United States Department of the Interior

Application Type: New Right-of-Way Pipeline
Application Date: May 25, 2005
Supplemental Data Date(s): October 17, 2005, November 28, 2005

One 8-inch pipeline 6.47 miles in length to transport bulk gas from DeSoto Canyon Area Block 618 Well No. 1 In-Line Sled (ILS), through DeSoto Canyon Area Blocks 619 and 620, to DeSoto Canyon Area Block 621 PLET; one associated 6-inch electro-hydraulic umbilical approximately 6.47 miles in length from DeSoto Canyon Area Block 618 Well No. 1 SUTA, through DeSoto Canyon Area Blocks 619 and 620, to DeSoto Canyon Area Block 621 SUTA.

Assigned Right-of-Way Number: OCS-G26864
Assigned Segment Number: 15166
Umbilical Segment Number: 15167

San Jacinto and Infield flow lines

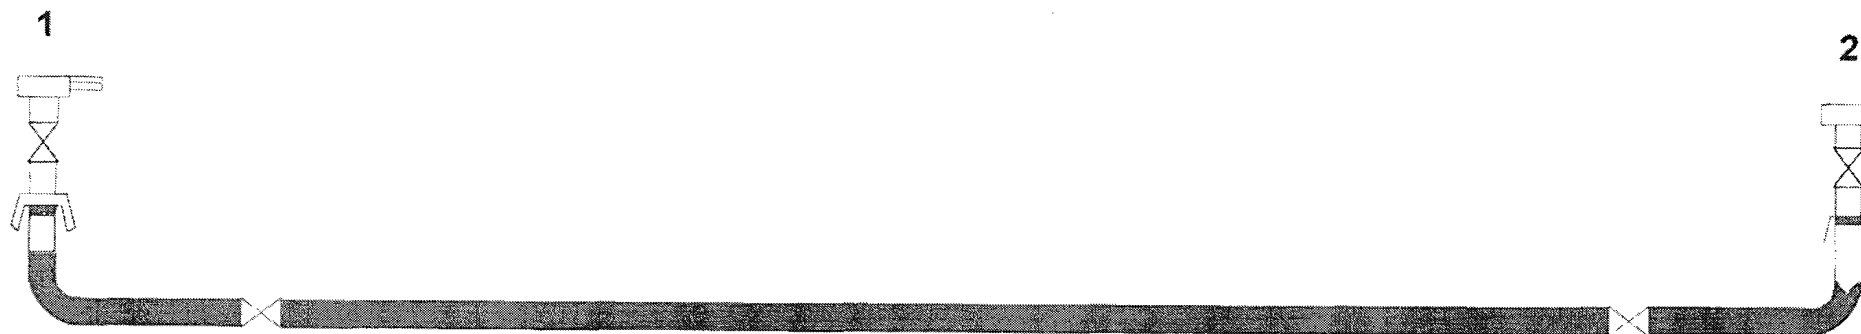
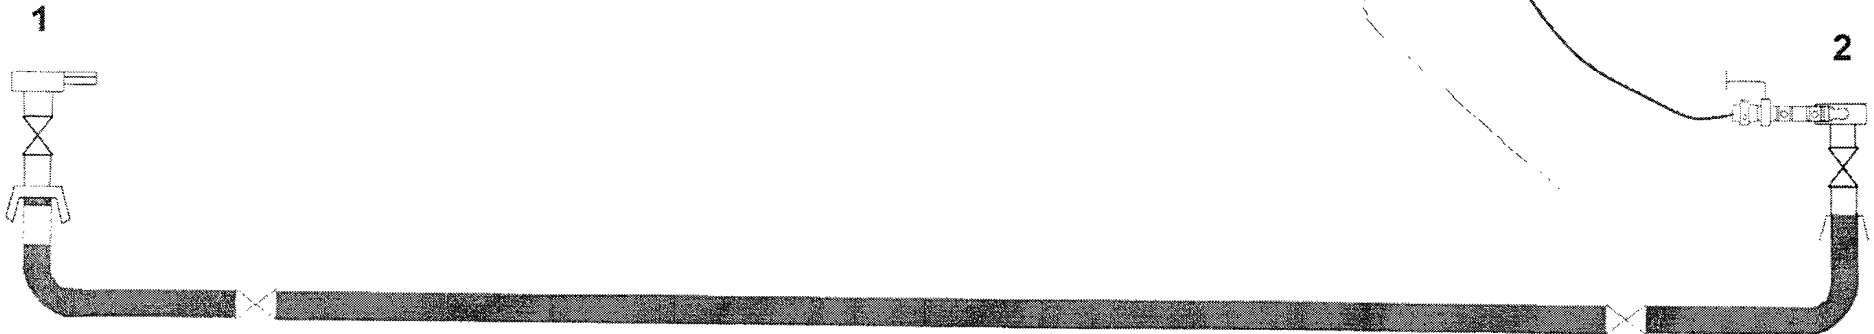
I need the following additional information regarding Item 4 concerning hydrostatic testing:

- 1.) Test measuring and recording devices proposed
- 2.) Summary of your hydrostatic testing procedure including general configuration showing the location of pressure measurement points

In response to the MMS request below for the subject application, please find attached a summary hydrotest procedure which includes schematics, summary procedures and testing equipment descriptions which should answer all of the questions raised. Please do not hesitate to call should you have any questions.

Flood and Prep
1.	Pre load pipe with pig at 2 onshore.
2.	Free Flood from 1.

Flood and Hydrotect
1. Re-flood with SPCS from 2.

DETAIL	1
1 : 1	-

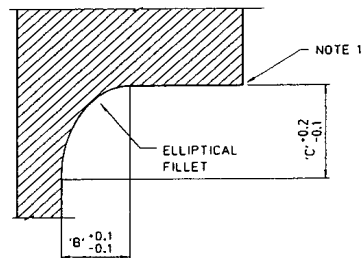
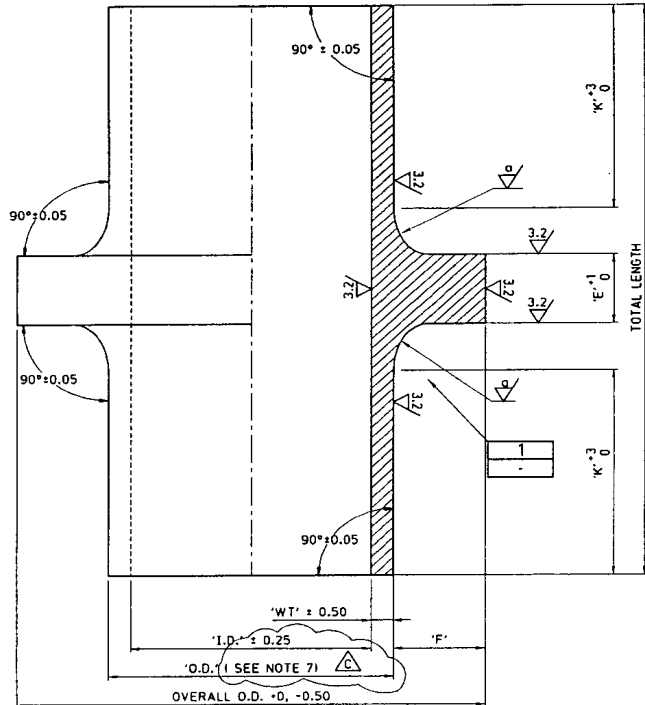
- 2.) Buckle arrestor type and material grade.

Reply: Buckle arrestors for this flowline will be supplied as Jlay collars which provide adequate buckle arrestor properties/dimension. They consist of ASTM A694 F65 forgings. Attached please find a dimensioned drawing. Reply to this flowline.
dimensions for the flowline on the drawing.

Reply: Buckle arrestors for this flowline will be supplied as Jlay collars which provide adequate buckle arrestor properties/dimensions. They consist of ASTM A694 F65 forgings. Attached please find a dimensioned drawing. dimensions for the flowline on the drawing apply to this flowline.
